## **2. REVISIONS TO DEIR TEXT**

This chapter presents all of the revisions made to the DEIR as a result of either staff-initiated changes or in response to comments received. New text is double underlined and deleted text is struck through. Text changes are presented in the page order in which they appear in the DEIR.

Figure 4.12-1  
Offsite Sewer Alignment  
Across Clover Valley Park

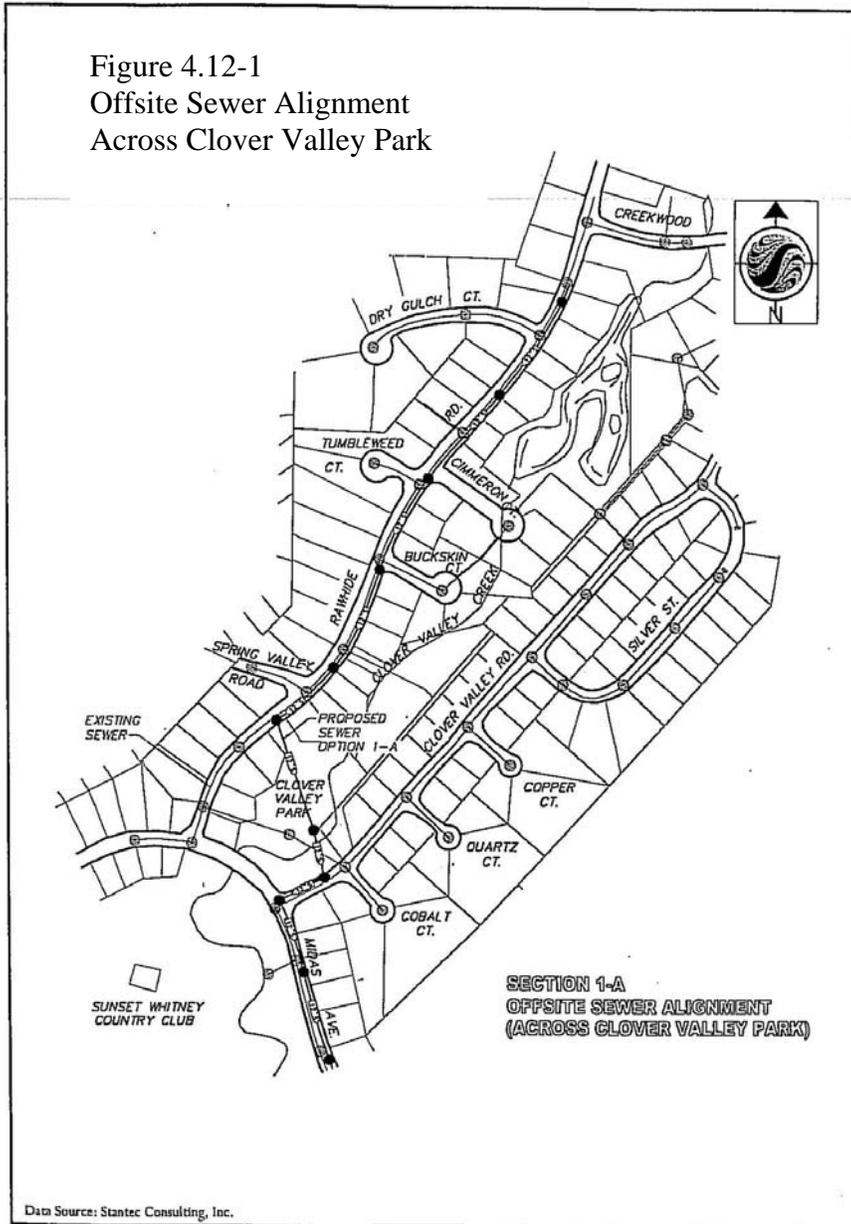
The commenter is correct. Figures 4.12-1 through 4.12-8 were inadvertently left out of the DEIR. The figures are included below and are hereby amended into the Public Services and Utilities chapter (Chapter 4.12) of the DEIR beginning at the bottom of Page 4.12-9.
